SUBJECT: ISSUANCE OF AMENDMENTS (TAC NOS. M89084 AND M89083)

The Commission has issued the enclosed Amendment No. 149 to Facility Operating License No. DPR-29 and Amendment No. 145 to Facility Operating License No. DPR-30 for the Quad Cities Nuclear Power Station, Units 1 and 2, respectively. The amendments are in response to your application dated March 11, 1994.

The amendments add new hydraulic snubbers on the main steamlines to the Technical Specifications (TS) for Quad Cities, Units 1 and 2, and also change the snubber visual inspection interval and corrective actions in TS Section 3.6.1 and 4.6.1 to the format and content of the Boiling Water Reactors (BWR) Standardized Technical Specifications (STS), as revised by Generic Letter 90-09, "Alternative Requirements for Snubber Visual Inspection Intervals and Corrective Actions," dated December 11, 1990.

Amendment No. 149
License No. DPR-29

Figure 4.6-2

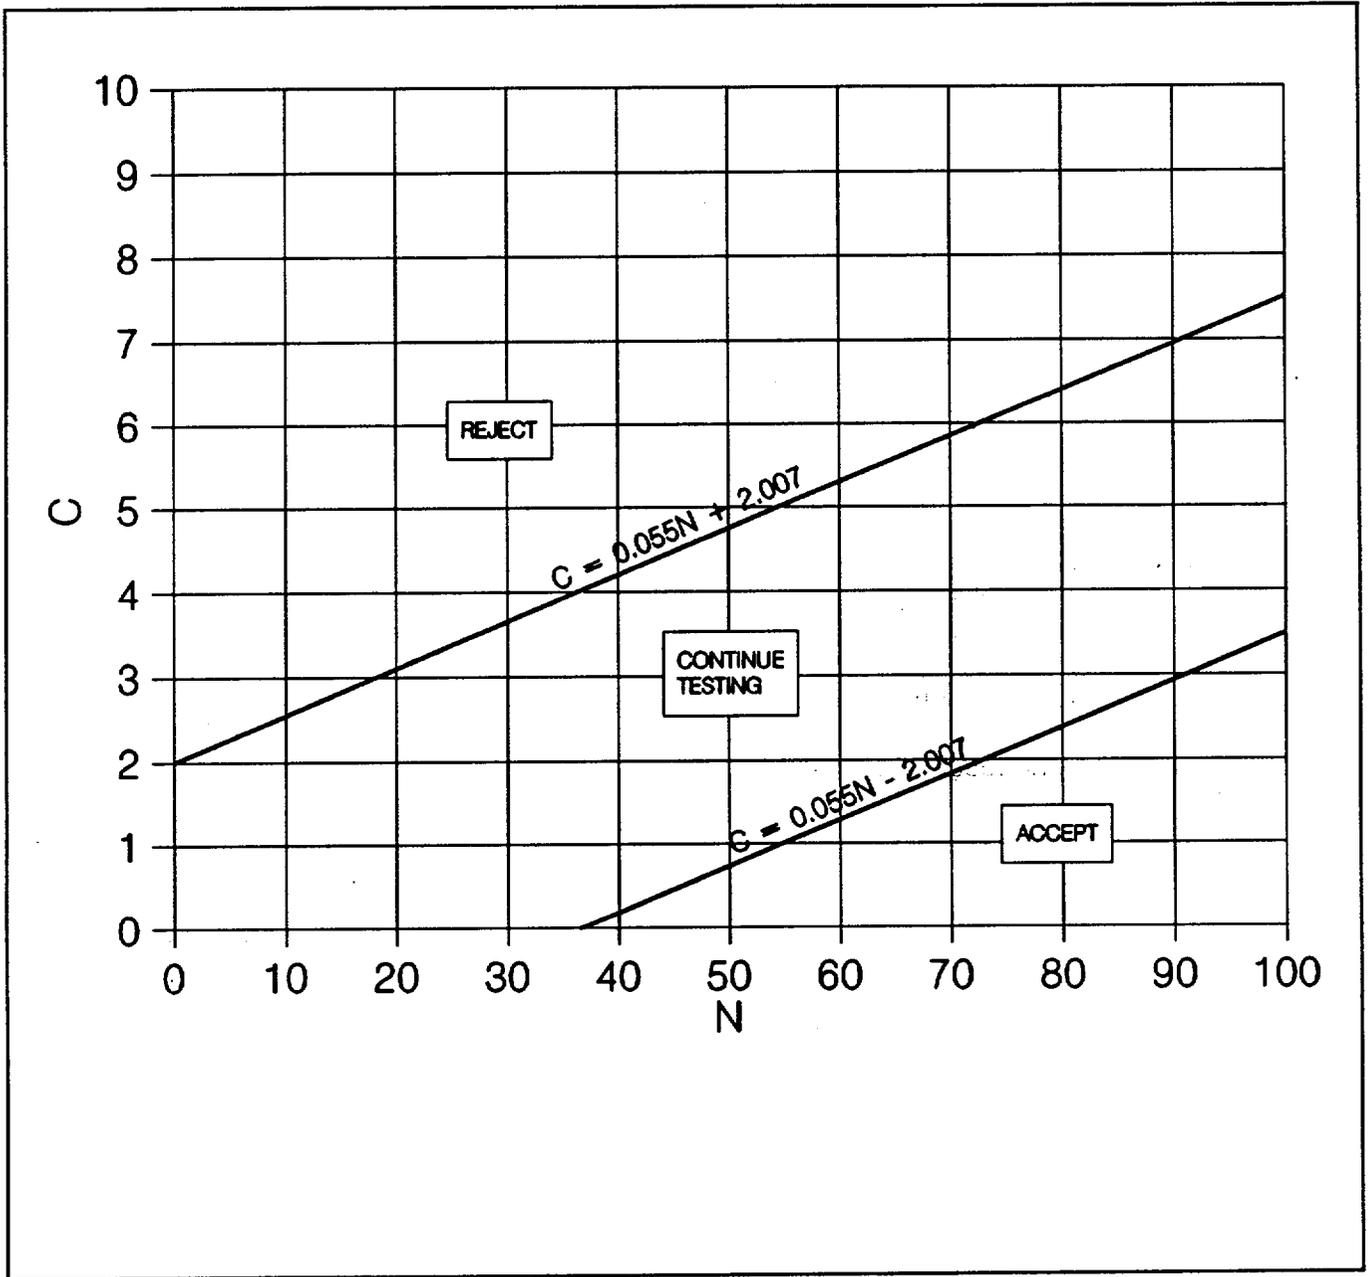
- a. At least 10% of the total of each type of snubber shall be functionally tested either in-place or in a bench test. For each snubber of a type that does not meet the functional test acceptance criteria of Specification 4.6.1.6, an additional 10% of that type of snubber shall be functionally tested until no more failures are found or until all snubbers of that type have been functionally tested; or
- b. A representative sample of each type of snubber shall be functionally tested, in accordance with Figure 4.6-2. "C" is the total number of snubbers of a type found not meeting the acceptance requirements of Specification 4.6.1.6. The cumulative number of snubbers of a type tested is denoted by "N". At the end of each day's testing, the new values of "N" and "C" (previous day's total plus current day's increments) shall be plotted on Figure 4.6-2.

If at any time the point plotted falls on or above the "Reject" line, all snubbers of that type shall be functionally tested. If at any time the point plotted falls on or below the "Accept" line, testing of snubbers of that type may be terminated. When the point plotted lies in the "Continue Testing" region, additional snubbers of that type shall be tested until the point falls in the "Accept" region or the "Reject" region, or all the snubbers of that type have been tested. Testing equipment failure during functional testing may invalidate that day's testing and allow that day's testing to resume anew at a later time, providing all snubbers tested with the failed equipment during the day of equipment failure are retested; or

1. Functionally test 10% of a type of snubber with an additional 10% tested for each functional testing failure, or
2. Functionally test a sample size and determine sample acceptance or rejection using Figure 4.6-2, or

Figure 4.6-2 was developed using "Wald's Sequential Probability Ratio Plan" as described in "Quality Control and Industrial Statistics" by Acheson J. Duncan.

Figure 4.6-2

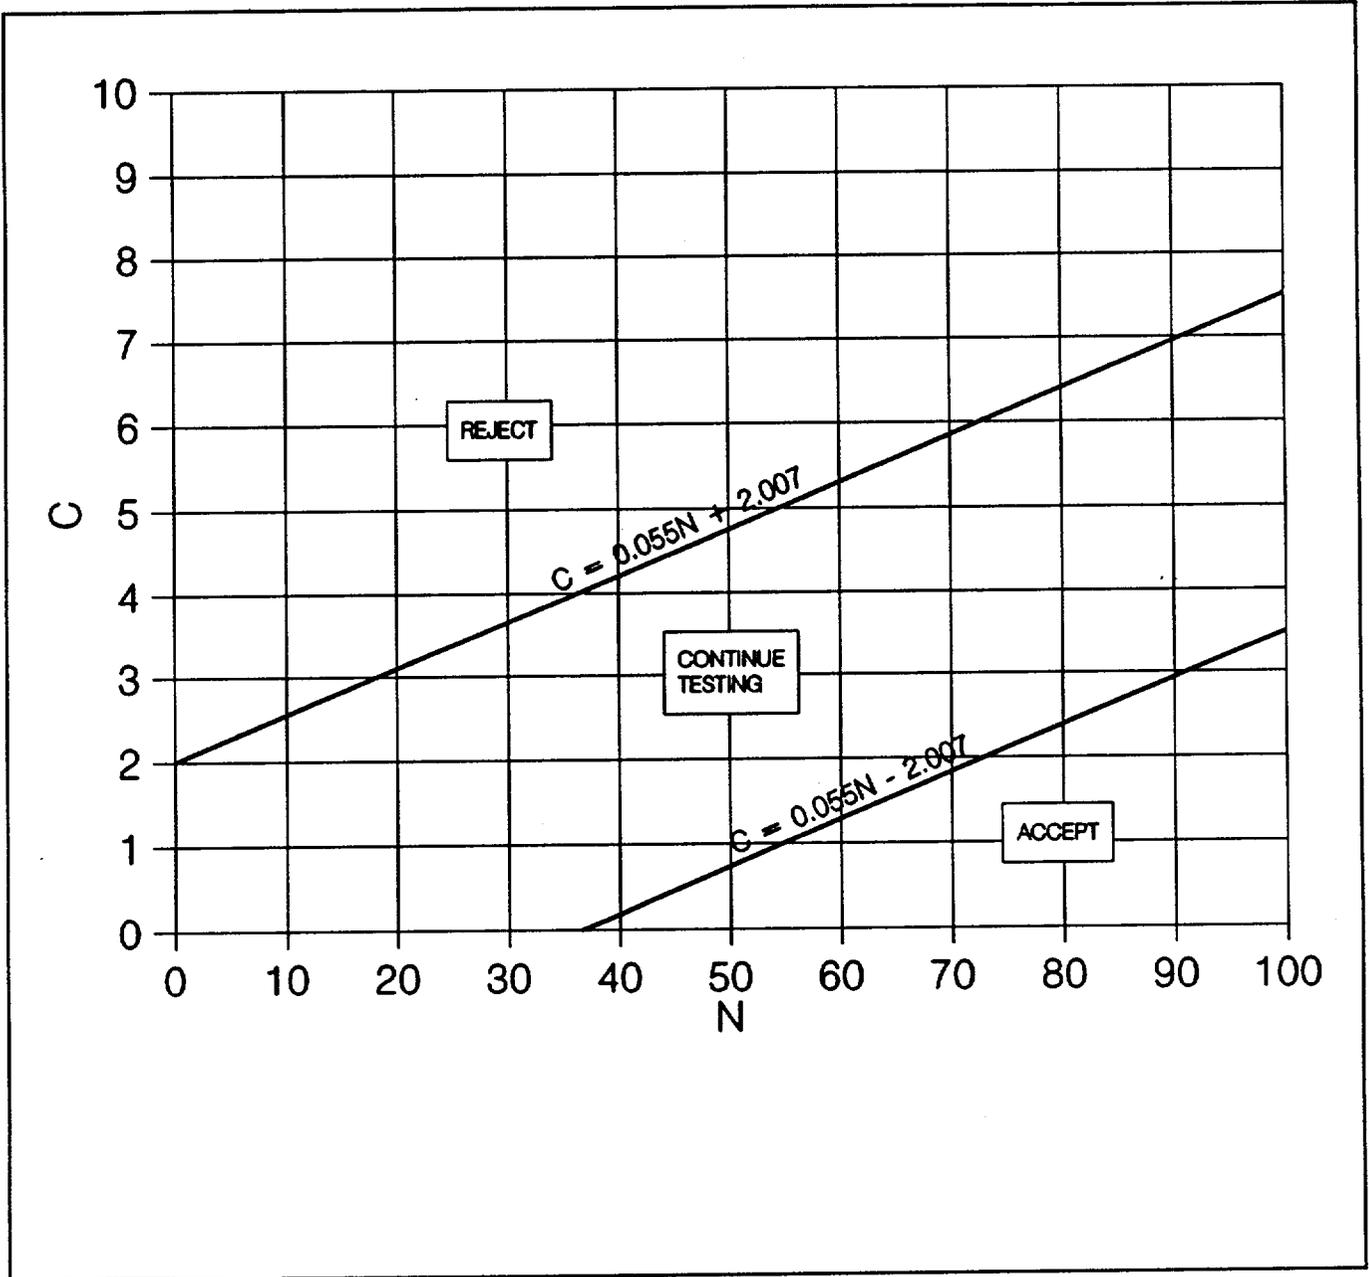
- a. At least 10% of the total of each type of snubber shall be functionally tested either in-place or in a bench test. For each snubber of a type that does not meet the functional test acceptance criteria of Specification 4.6.1.6, an additional 10% of that type of snubber shall be functionally tested until no more failures are found or until all snubbers of that type have been functionally tested; or
- b. A representative sample of each type of snubber shall be functionally tested, in accordance with Figure 4.6-2. "C" is the total number of snubbers of a type found not meeting the acceptance requirements of Specification 4.6.1.6. The cumulative number of snubbers of a type tested is denoted by "N". At the end of each day's testing, the new values of "N" and "C" (previous day's total plus current day's increments) shall be plotted on Figure 4.6-2.

If at any time the point plotted falls on or above the "Reject" line, all snubbers of that type shall be functionally tested. If at any time the point plotted falls on or below the "Accept" line, testing of snubbers of that type may be terminated. When the point plotted lies in the "Continue Testing" region, additional snubbers of that type shall be tested until the point falls in the "Accept" region or the "Reject" region, or all the snubbers of that type have been tested. Testing equipment failure during functional testing may invalidate that day's testing and allow that day's testing to resume anew at a later time, providing all snubbers tested with the failed equipment during the day of equipment failure are retested; or

1. Functionally test 10% of a type of snubber with an additional 10% tested for each functional testing failure, or
2. Functionally test a sample size and determine sample acceptance or rejection using Figure 4.6-2, or

Figure 4.6-2 was developed using "Wald's Sequential Probability Ratio Plan" as described in "Quality Control and Industrial Statistics" by Acheson J. Duncan.
